SUPPLEMENT TO THE
SAFETY EVALUATION REPORT
FOR
THE PWR COOLANT CHEMISTRY LOOP (PCCL)
MITNRL-020

to be
installed and operated in the
MITR

April 19, 1988

For Review by the
MITR Safeguards Committee
and by its
PCCL Subcommittee

Figure 1.1a Schematic of PWR Coolant Chemistry Loop

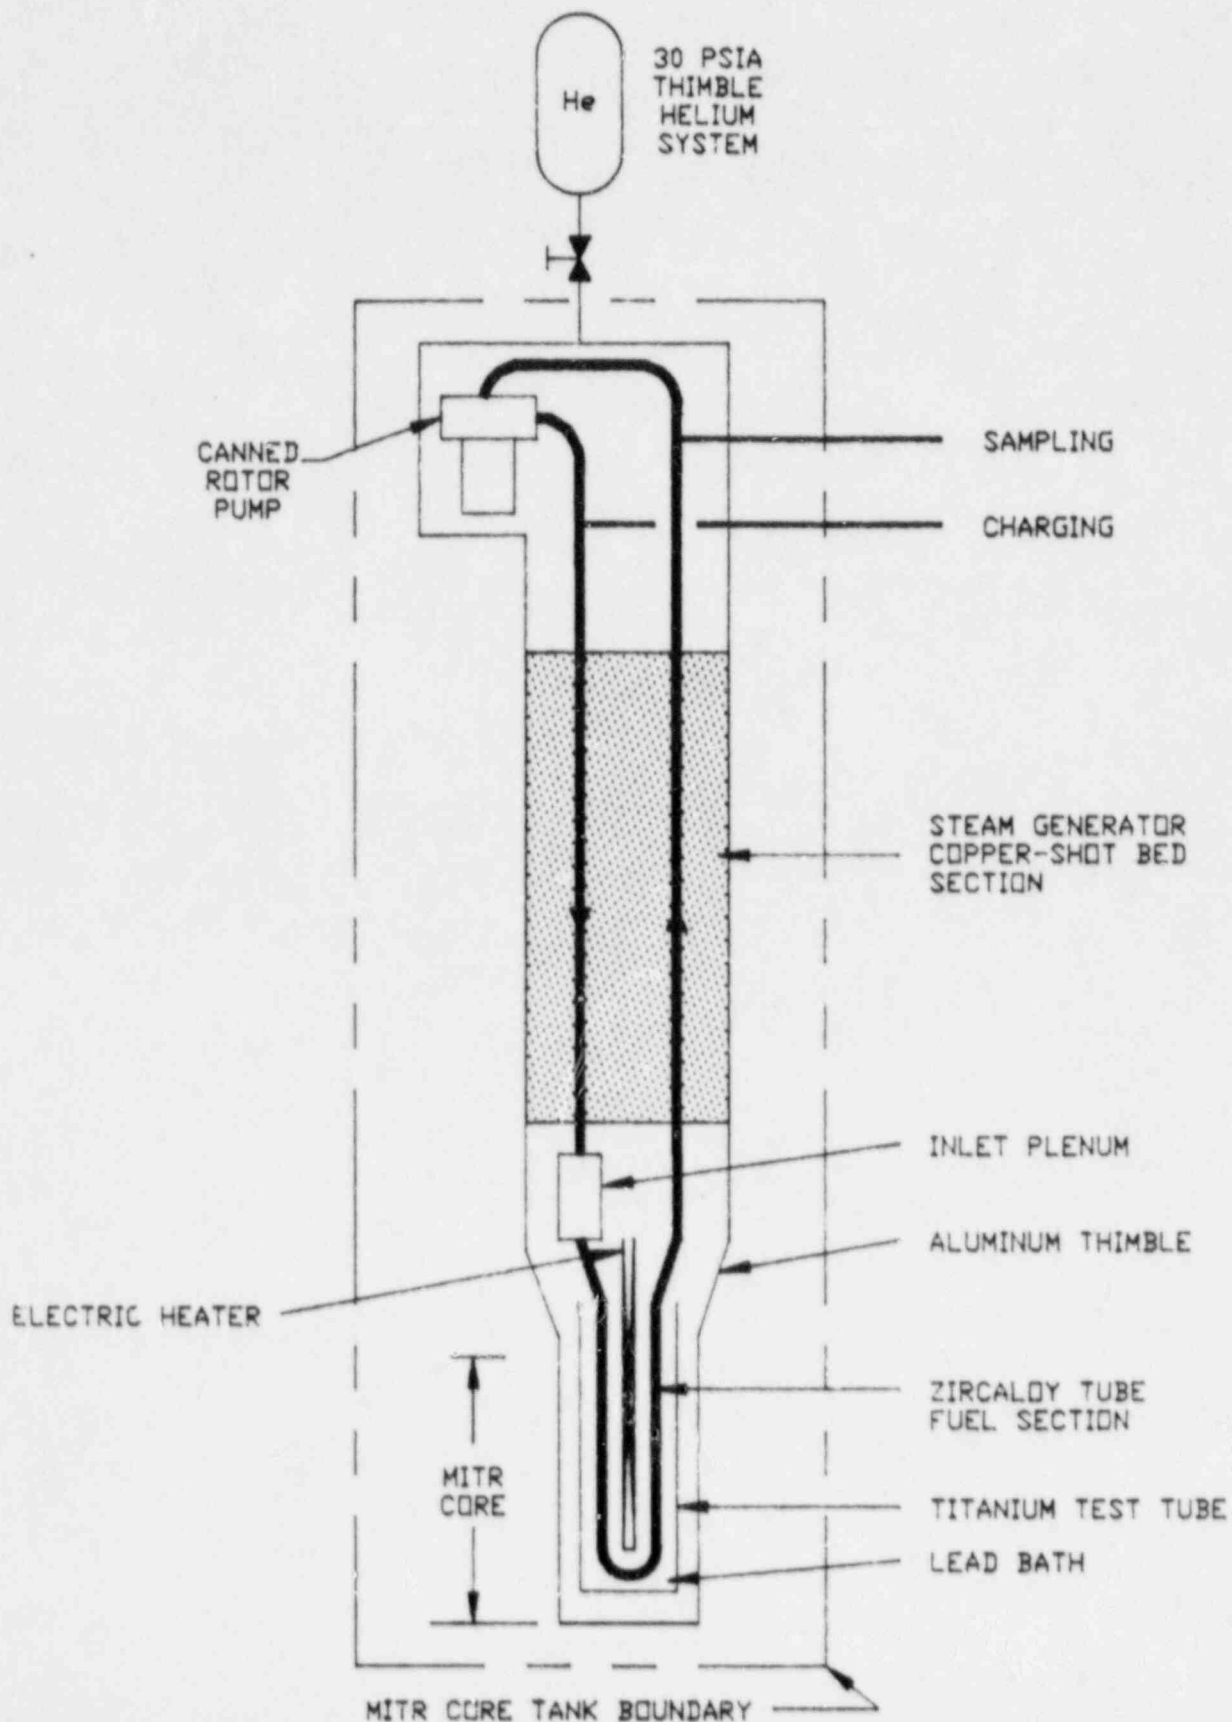
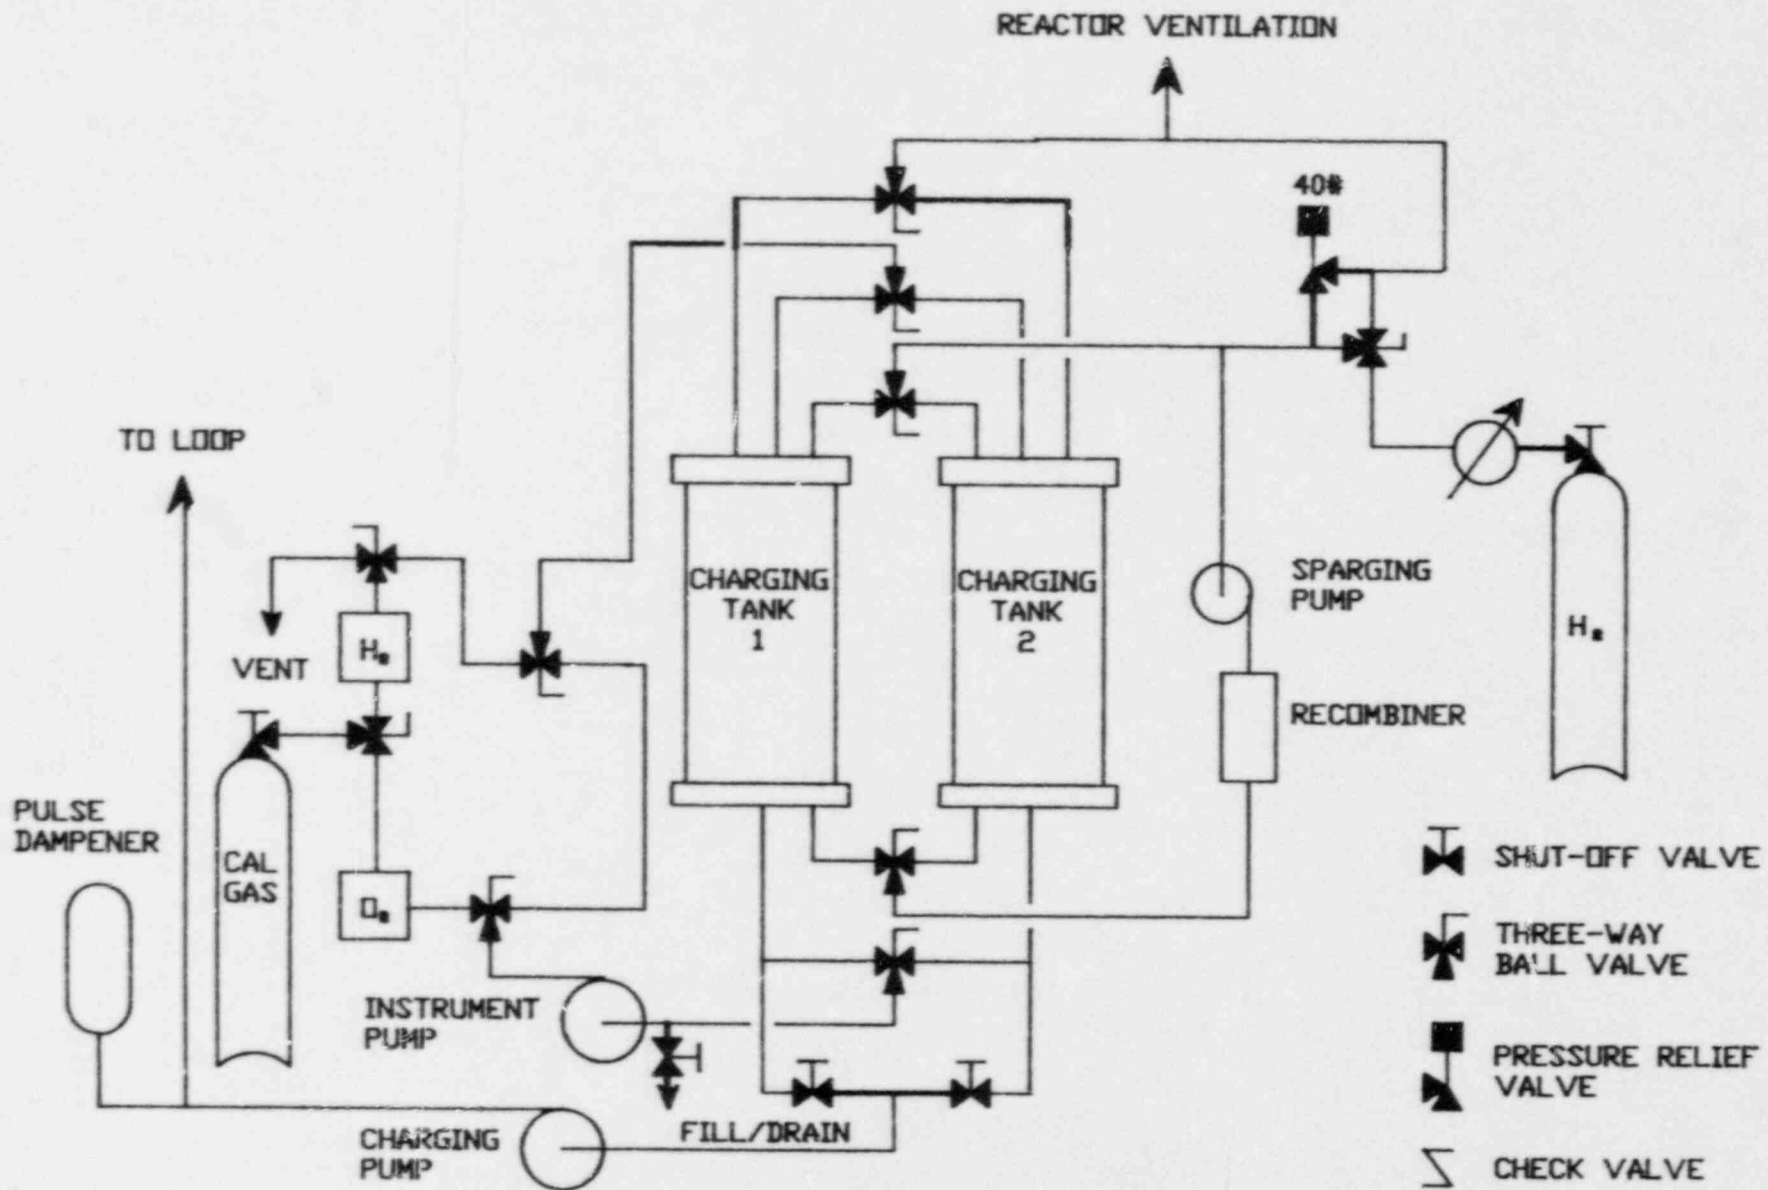
Revised versions of Figure 1.1 a) and b) and Table 2.1 are provided. Important changes to note for portions of the loop inside the MITR-II Core tank:

- only one plenum (on the core inlet) is now provided in the loop tubing,

- a flowmeter will not be used; flow will be inferred from power and temperature data calibrated by out-of-pile testing (under normal circumstances, flow is directly related to the circulating pump input frequency, which is controlled),

- the titanium lead bath container has been strengthened with weld beads to prevent deformation during operation at temperature,

- the aluminum fusible link has been eliminated and passive failure of the heater as a safety feature has been de-emphasized in favor of redundant trips without common mode failure possibilities,

FIGURE 1.1.b-1

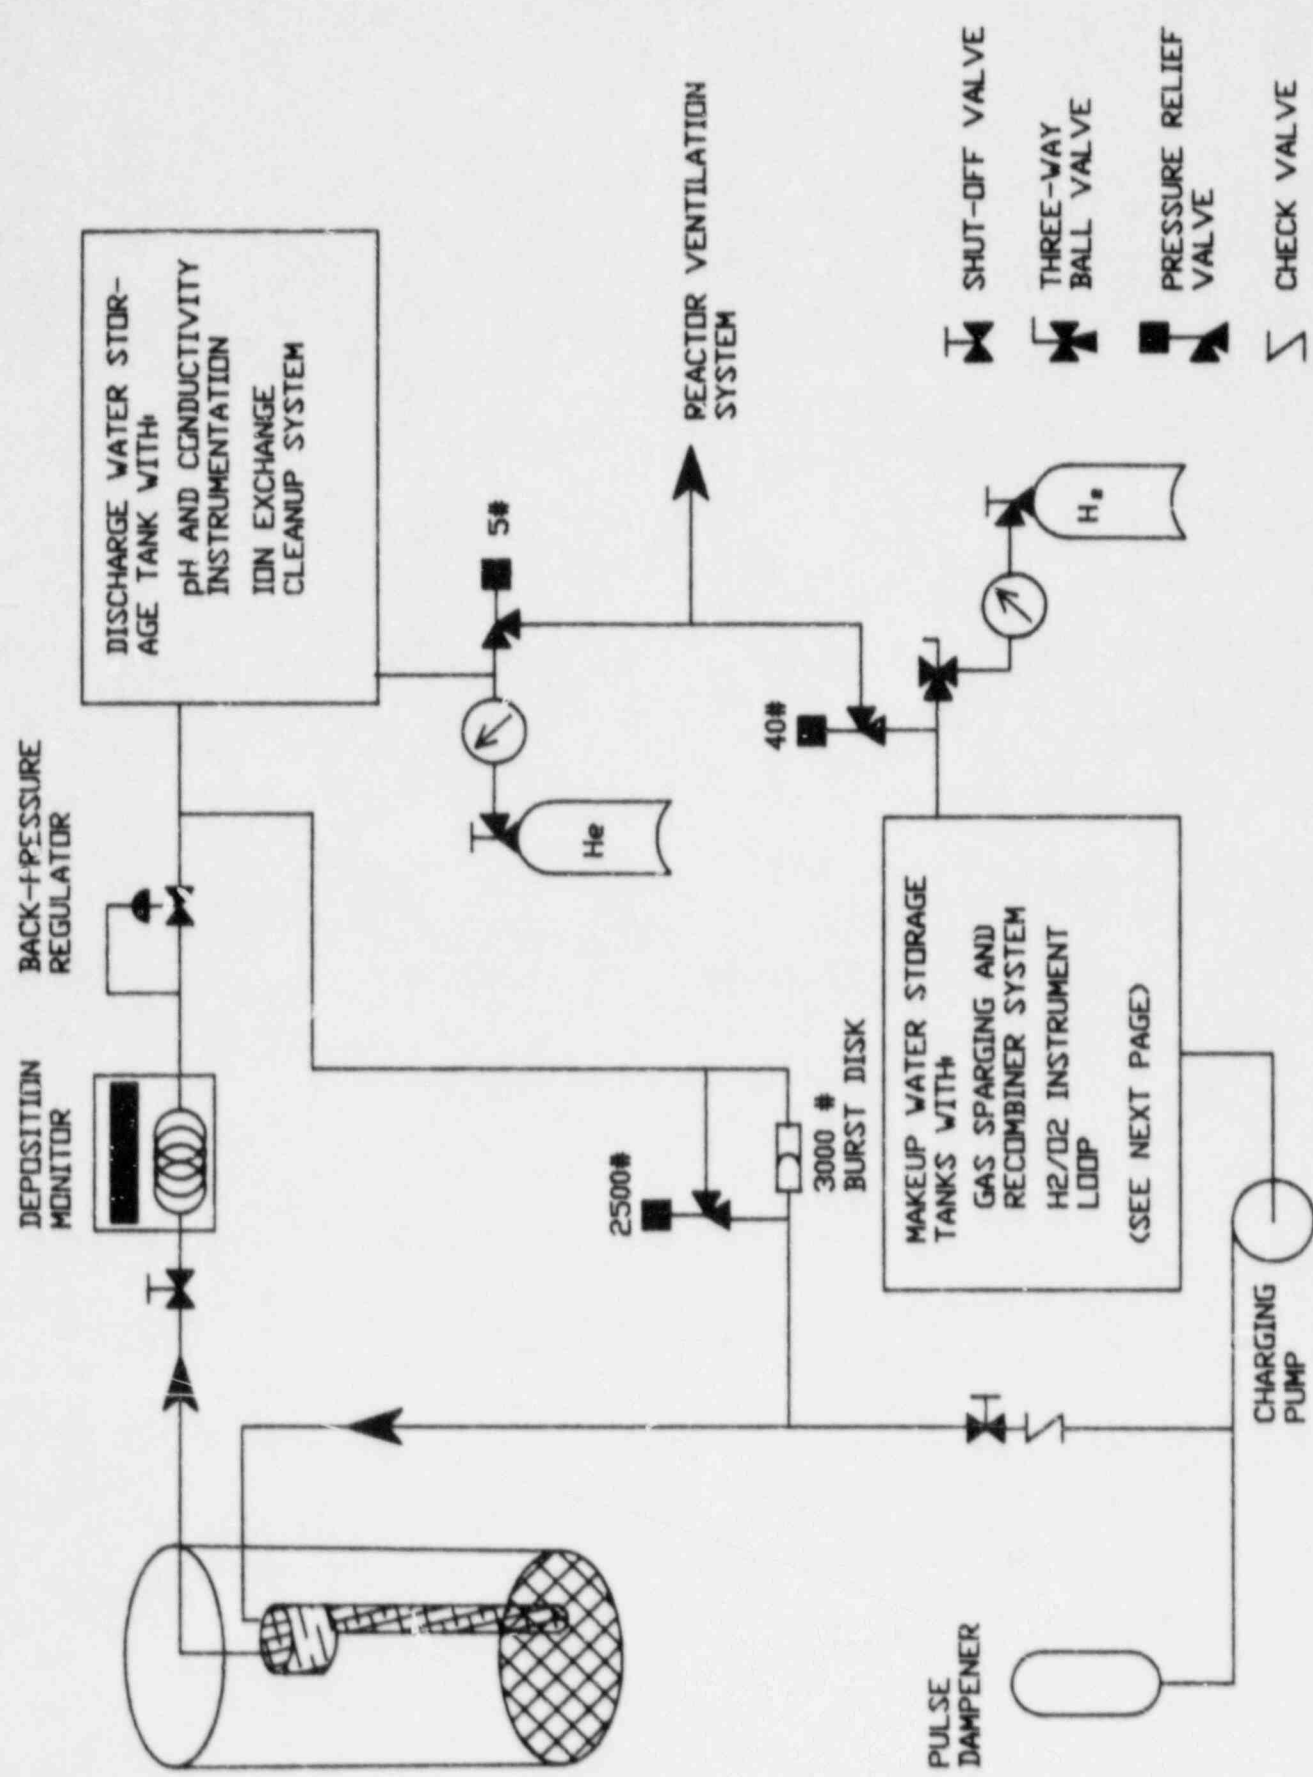
--the 3000 psig pressure relief valve has been replaced by a burst disk,

--two 1.75 ft.³ pyrex tanks will be used for charging water storage to allow flexibility in run length and/or charging rate without interrupting charging flow to the loop; only one charging tank will be valved in at any time, except during manual tank changeover operations; the charging system has been fully tested in a 1000-hour-long run, supplying make-up water to prefilm a set of ten loop segments being prepared for later in-pile experiments,

--The back-pressure regulator has been moved to the discharge of the loop, replacing the let-down flow control capillary (see discussion below).

--since the charging pump incorporates check valves only one additional check valve is planned for the loop.

FIG. 51. SUMMARY OF HEATER MODIFICATIONS

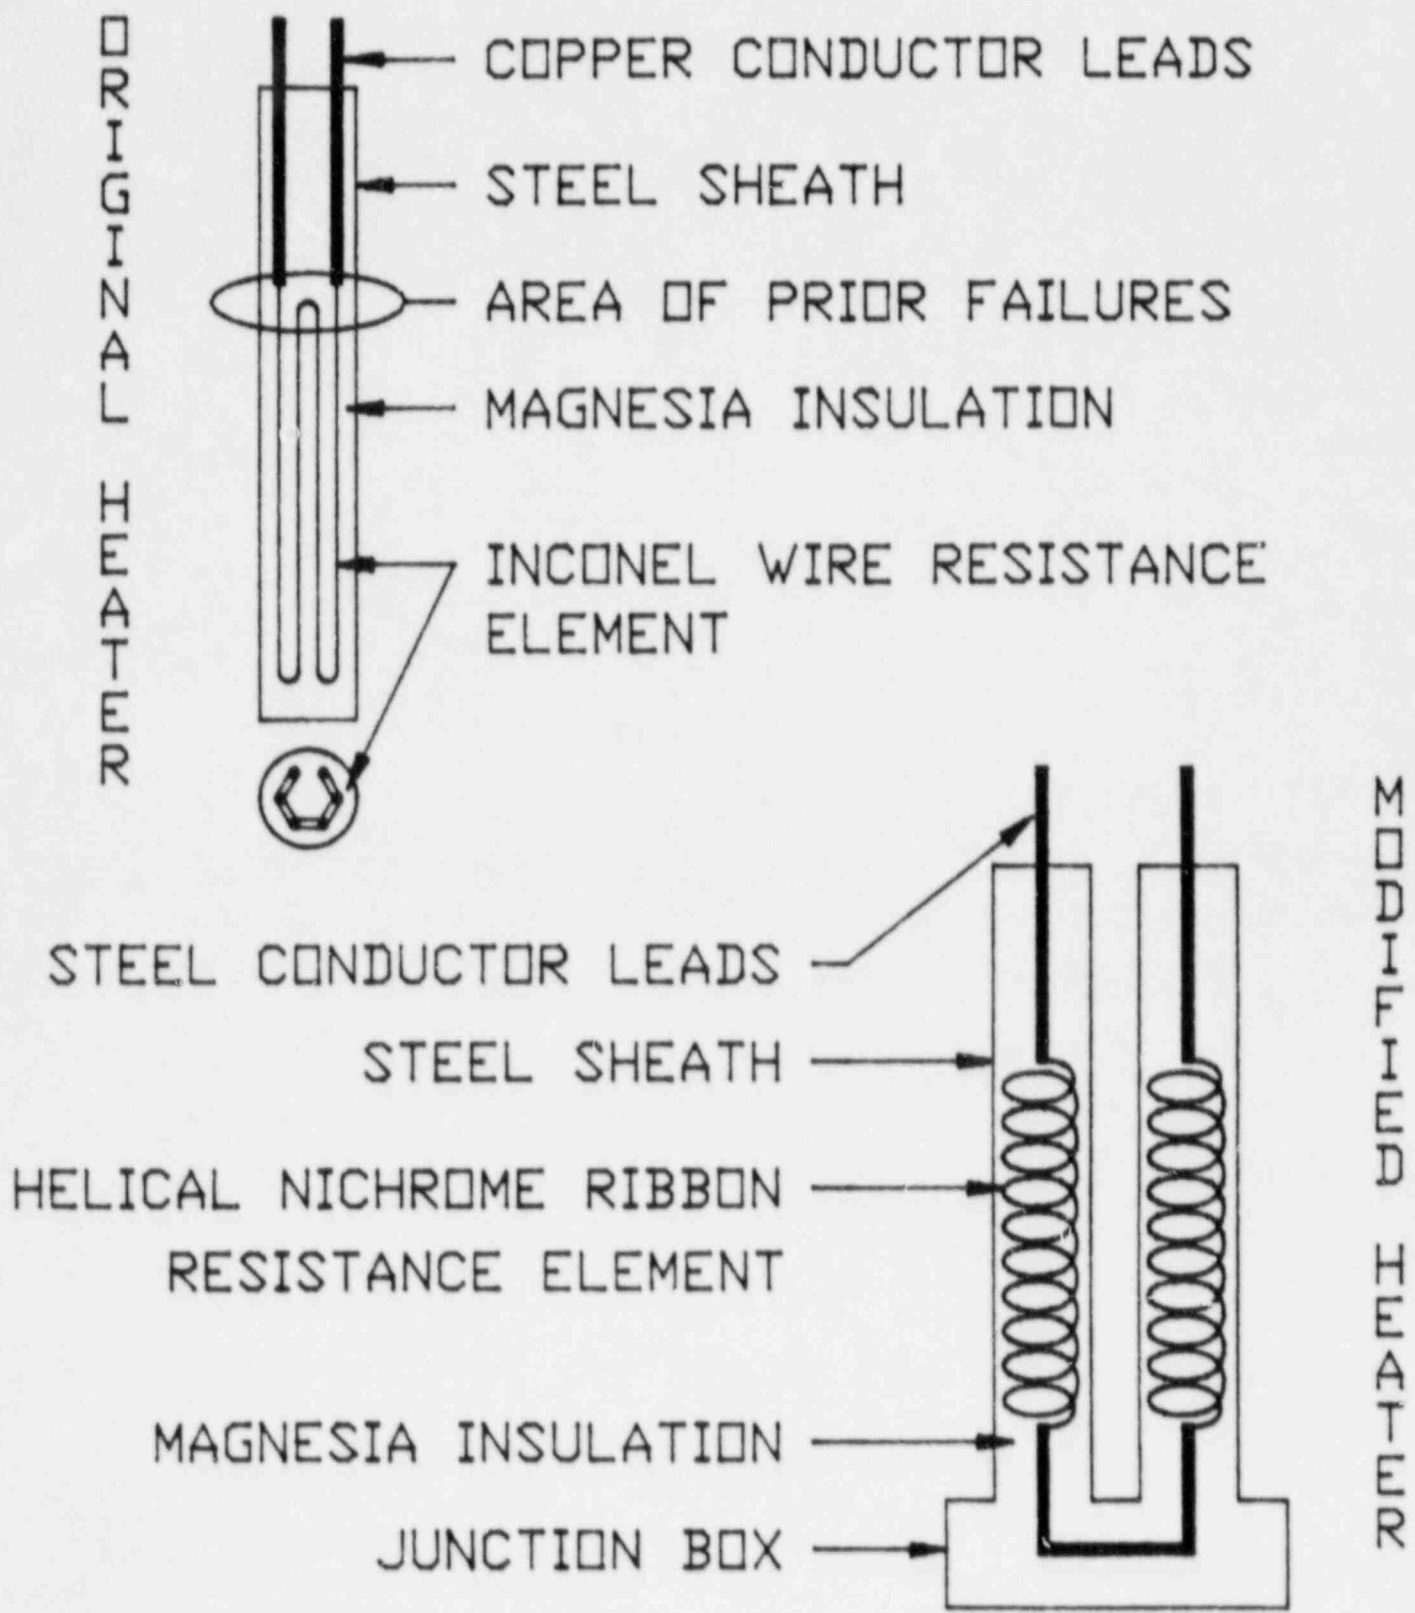
- the most recent heater design was a two-element "U" configuration in place of the former single sheath, multi-pass heater, see Fig. S1 and further discussion below,

The current heater design is illustrated schematically in Fig. S1. It is expected that this heater will be considerably more rugged than previous ones: power per foot of length has been halved and the helical element is more compliant under thermal stresses. This heater is currently undergoing endurance testing and this design is likely to become the standard model for future applications.
